**SHADY SHORES TOWN COUNCIL
SHADY SHORES PLANNING AND ZONING COMMISSION
SPECIAL CALLED JOINT MEETING
DECEMBER 6, 2022; 6:30 PM
101 S.SHADY SHORES ROAD
SHADY SHORES, TX 76208**

Re: Plat Approval Request for Lots 1-5, Block A Herd Addition
Town of Shady Shores
Project No. 0160012012

TOWN ENGINEER
Comments
11-29-2022
Revise and Resubmit

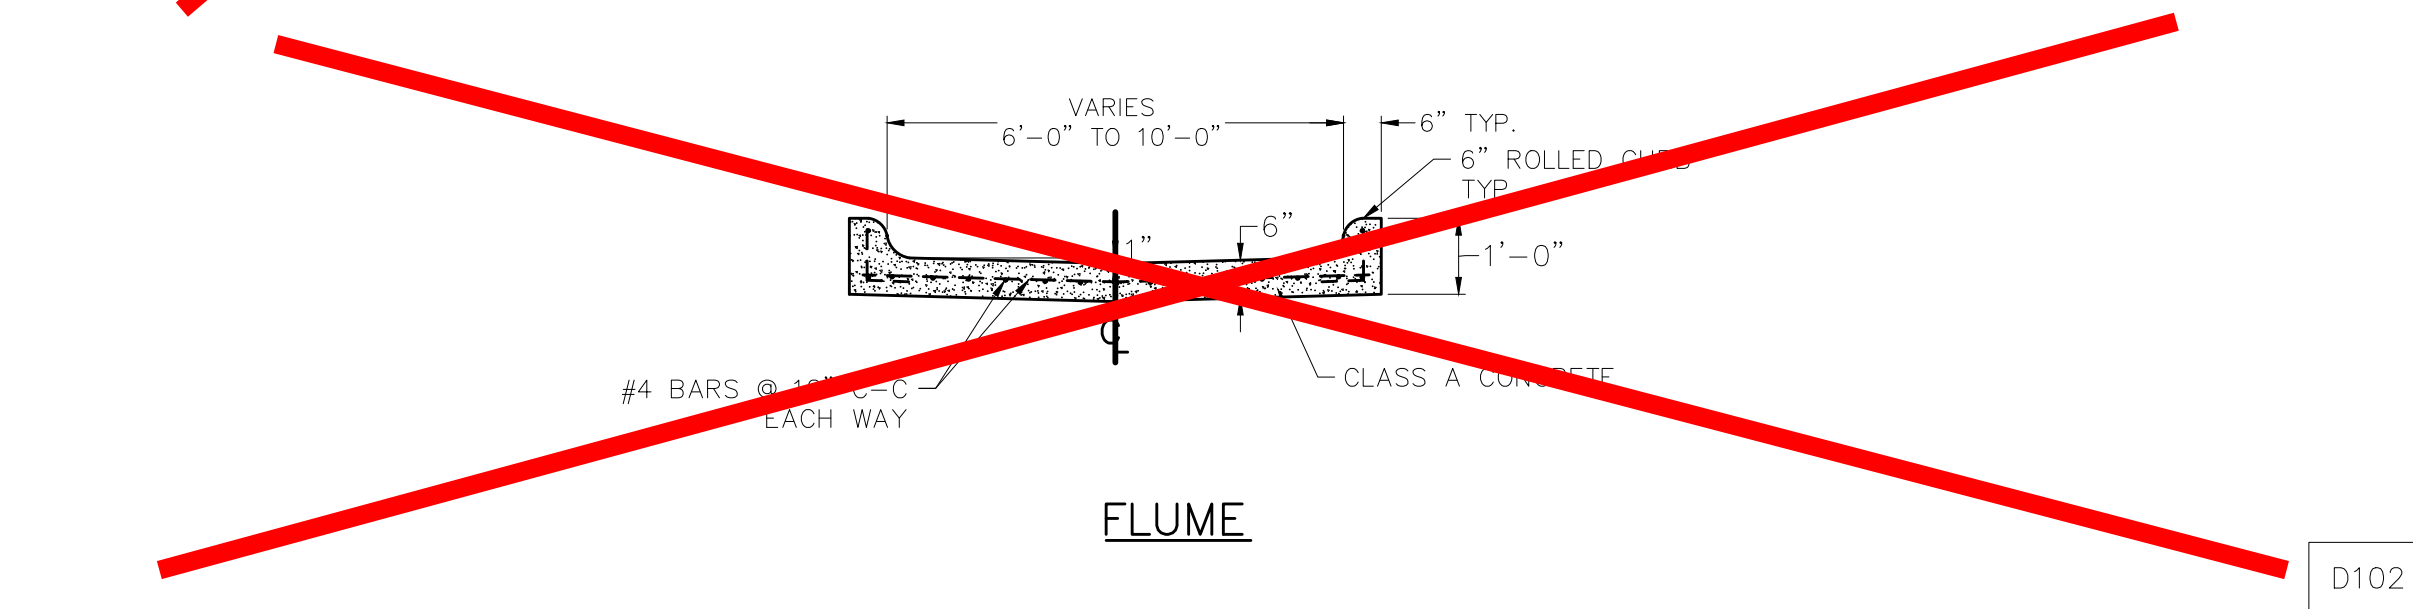
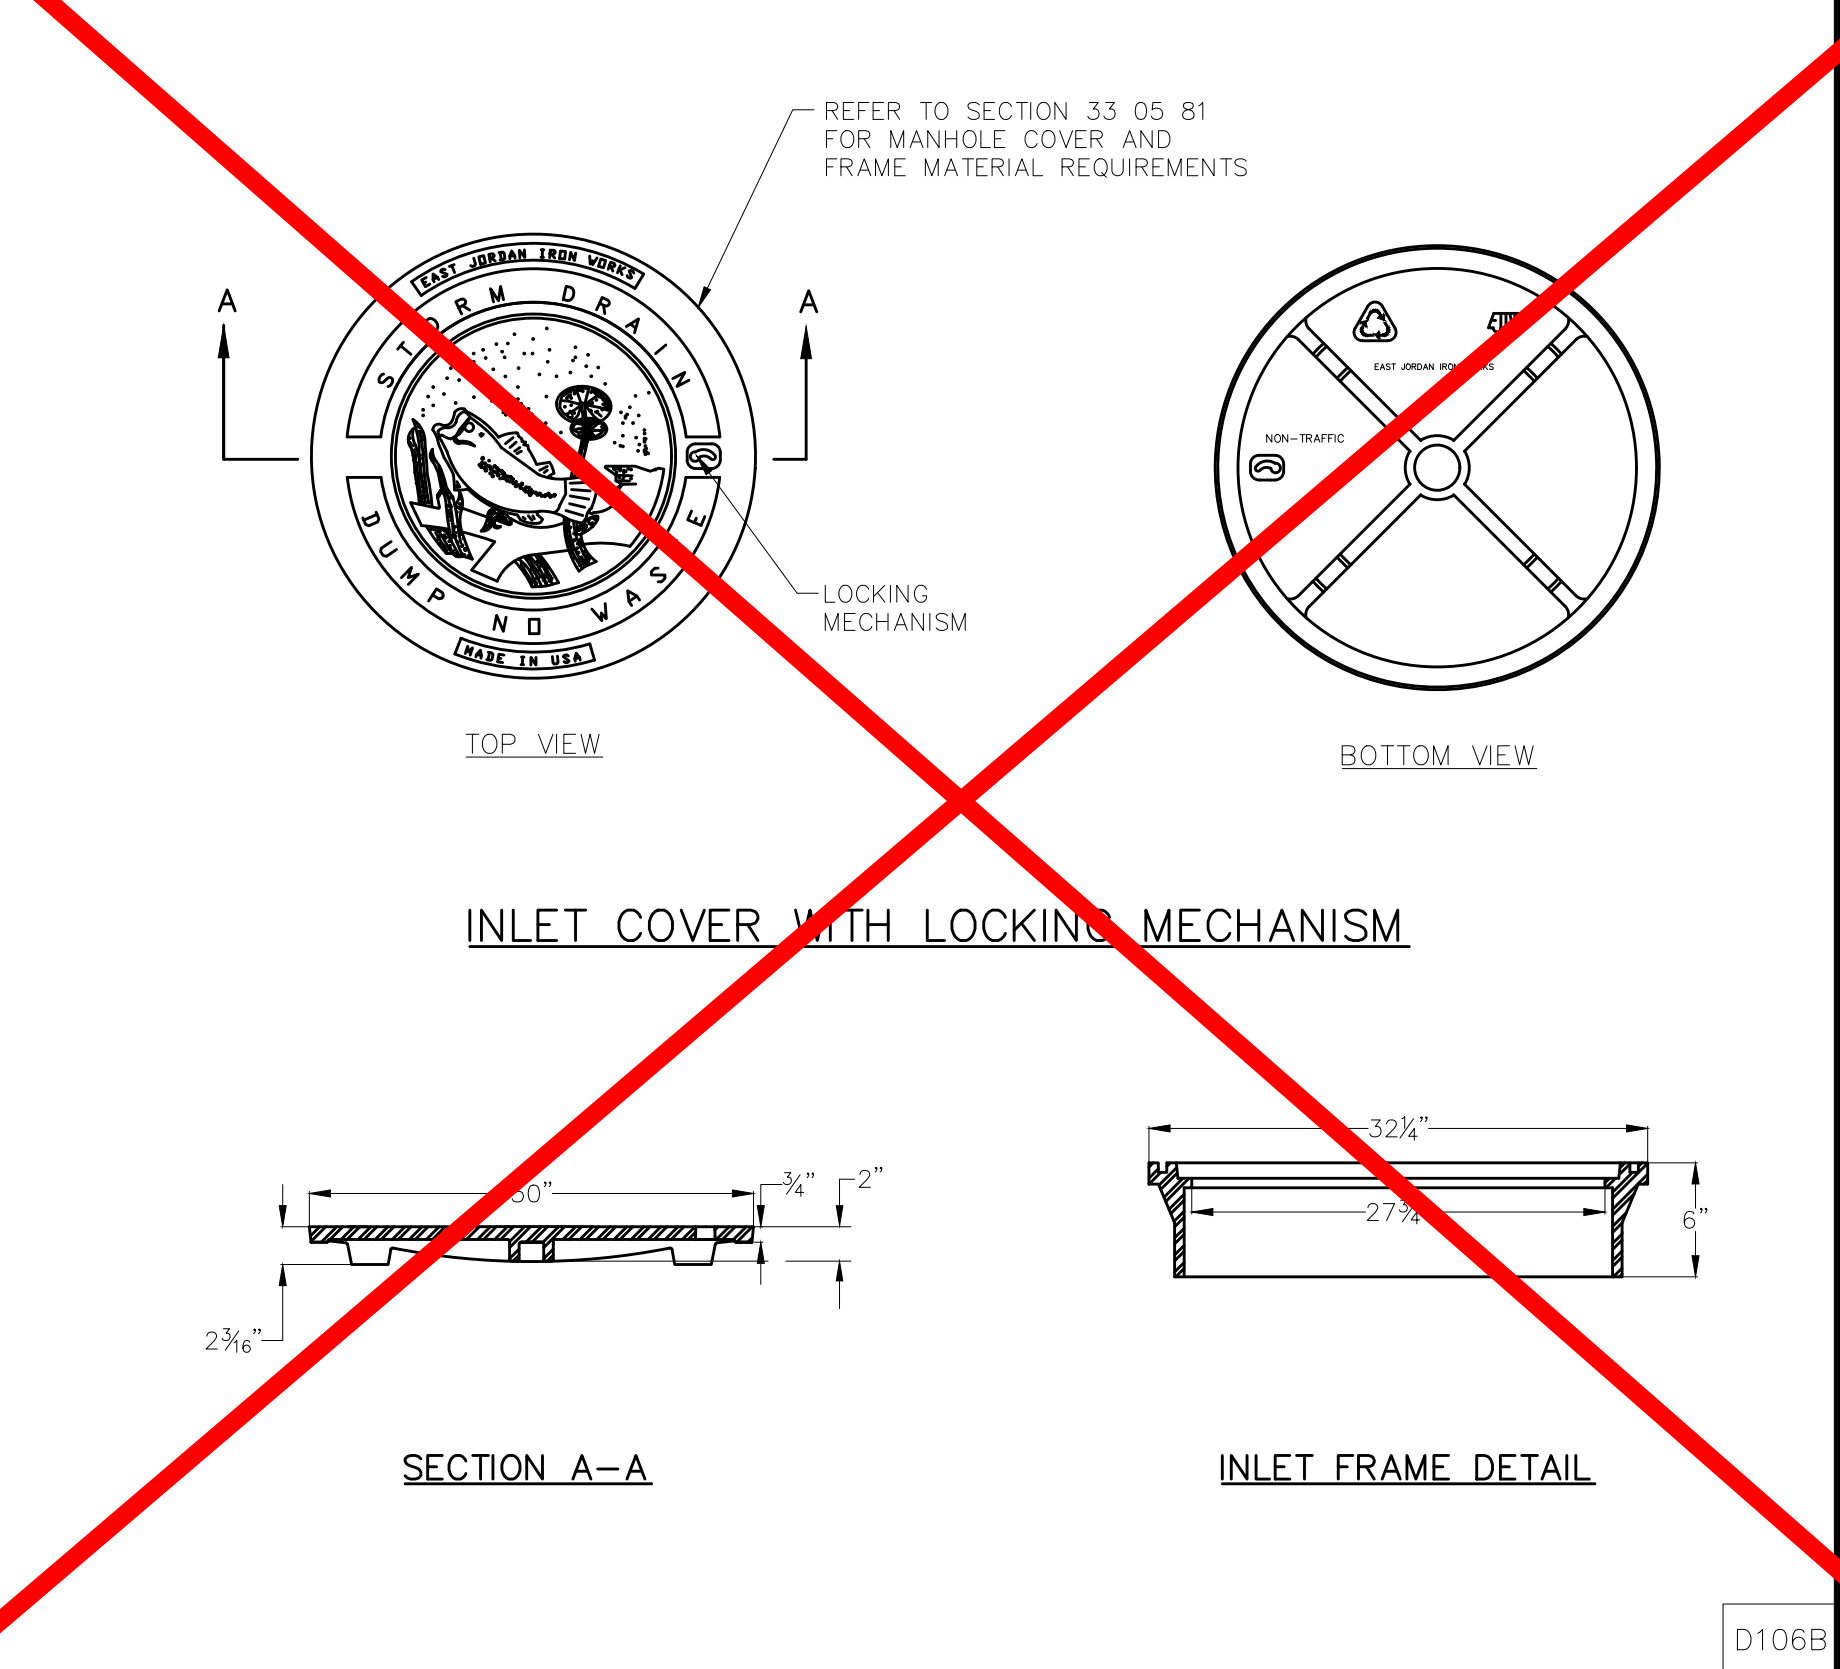
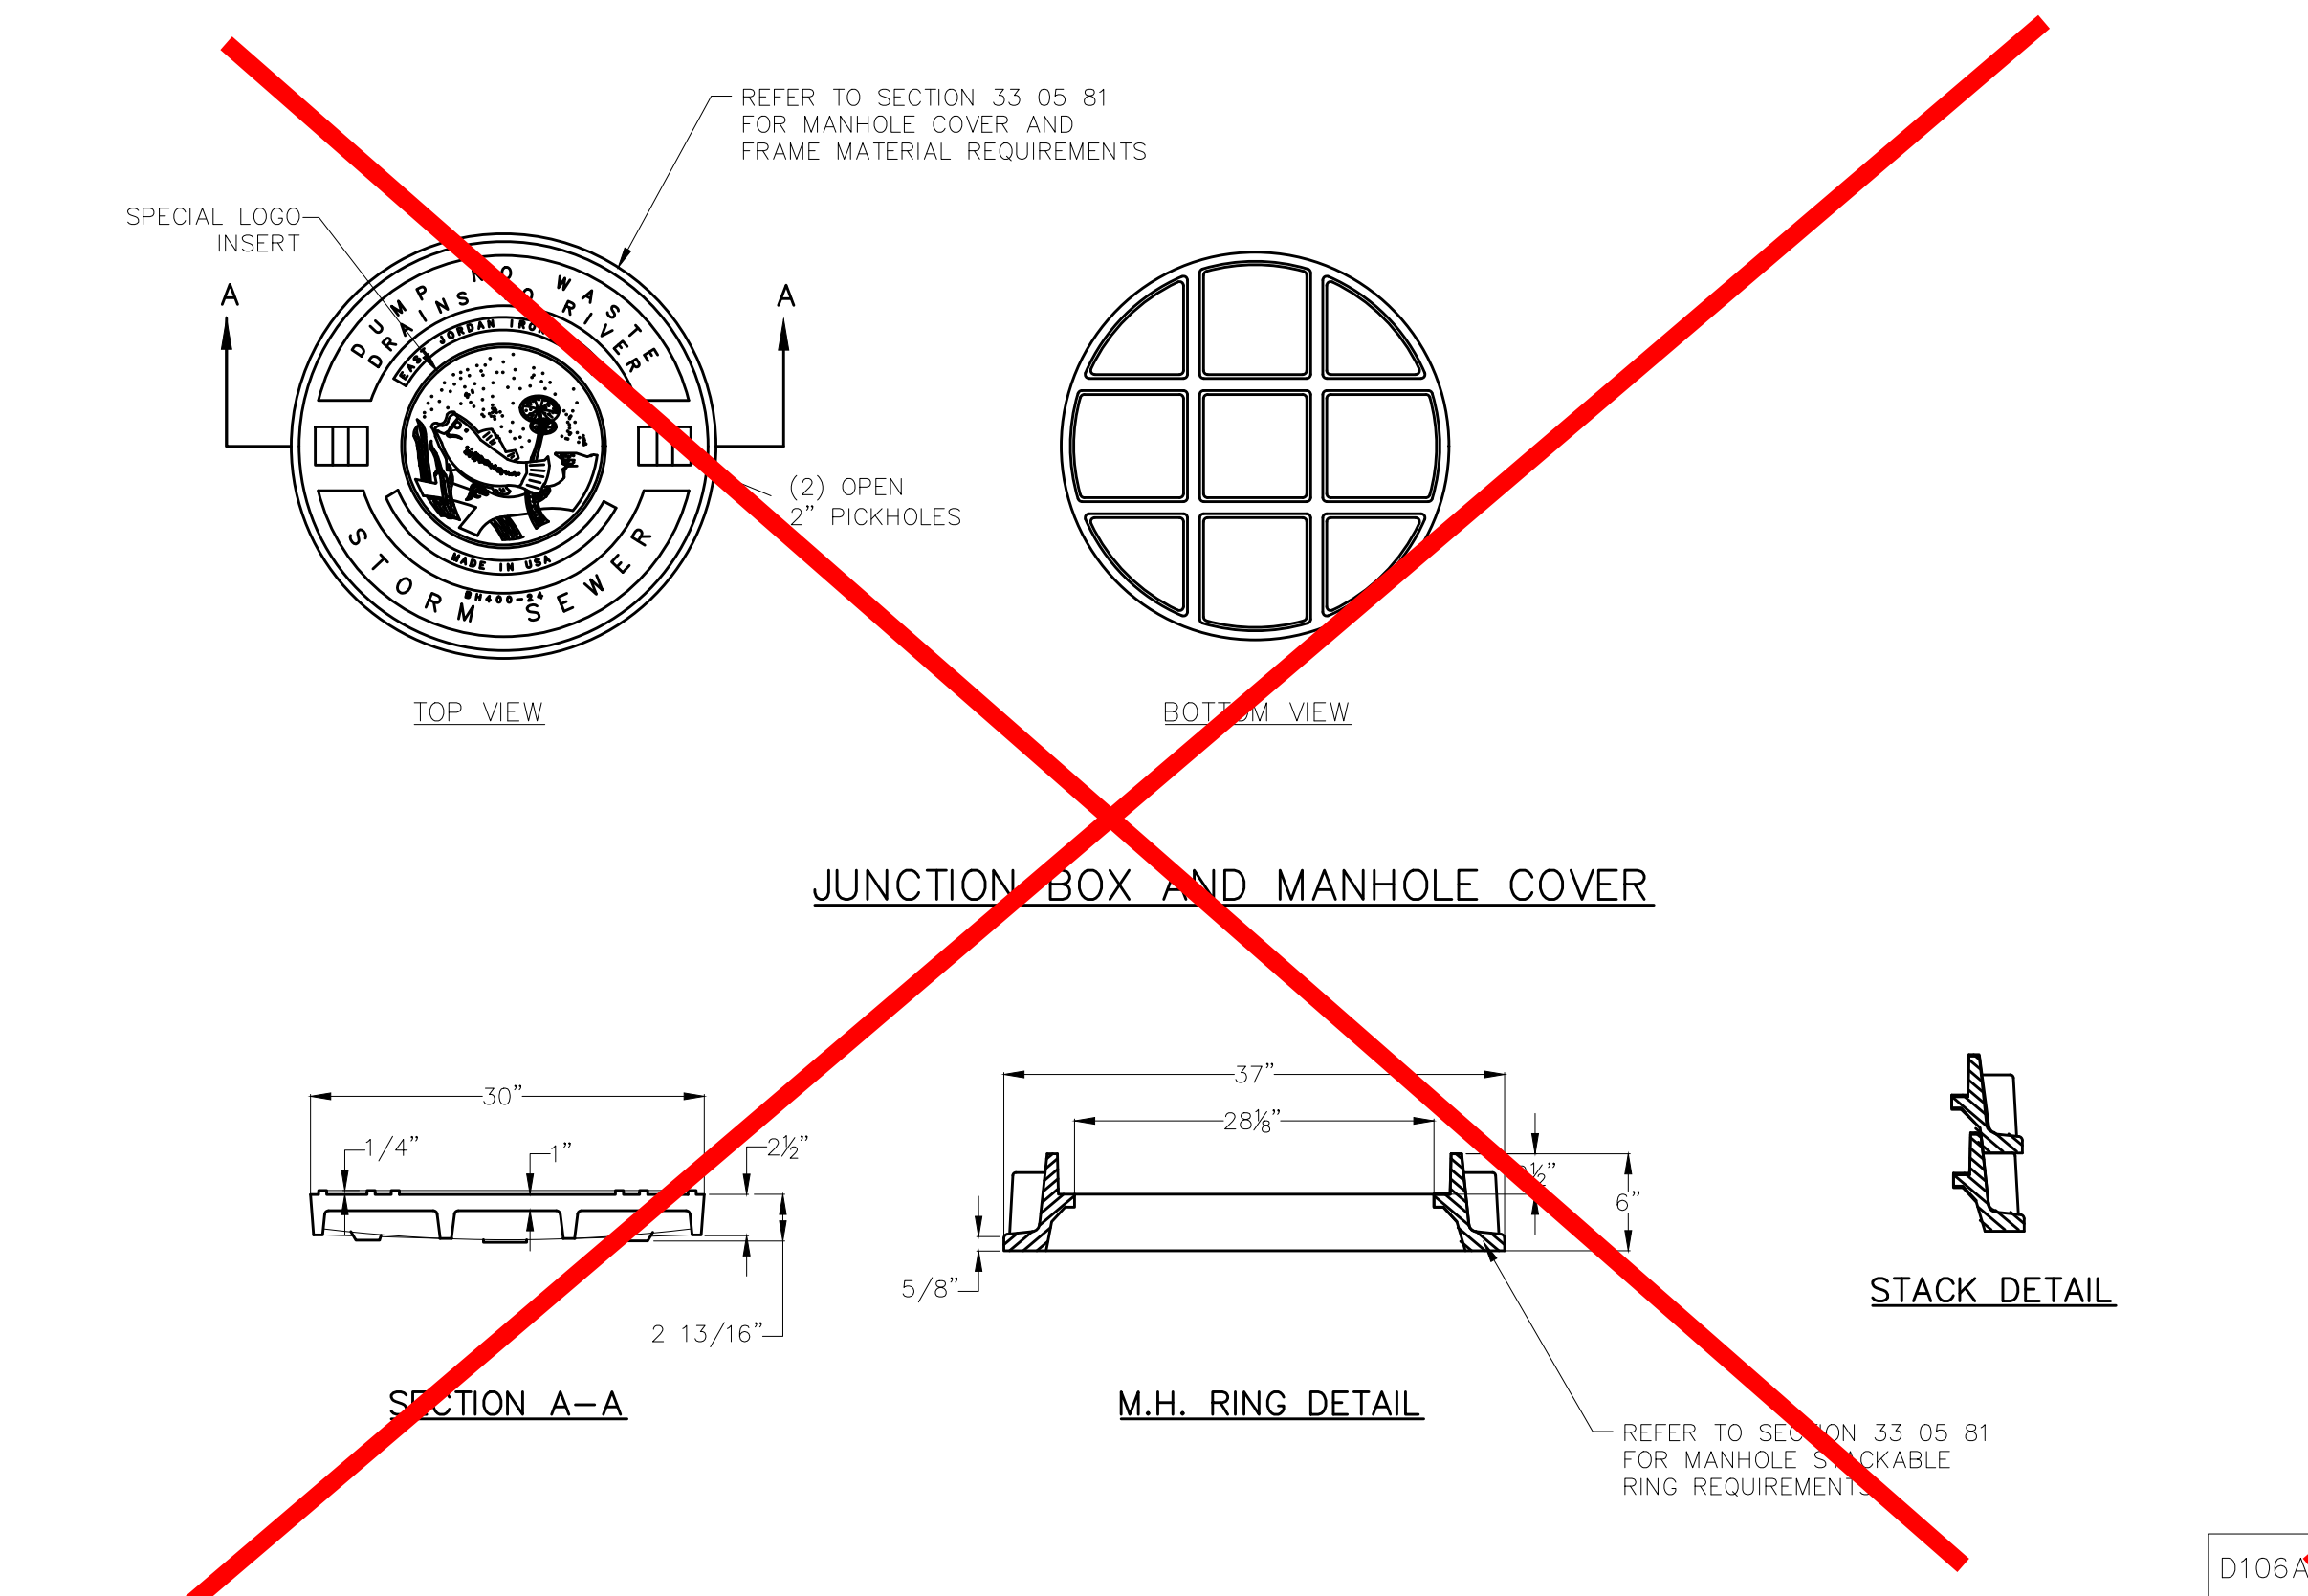
cross out details not applicable
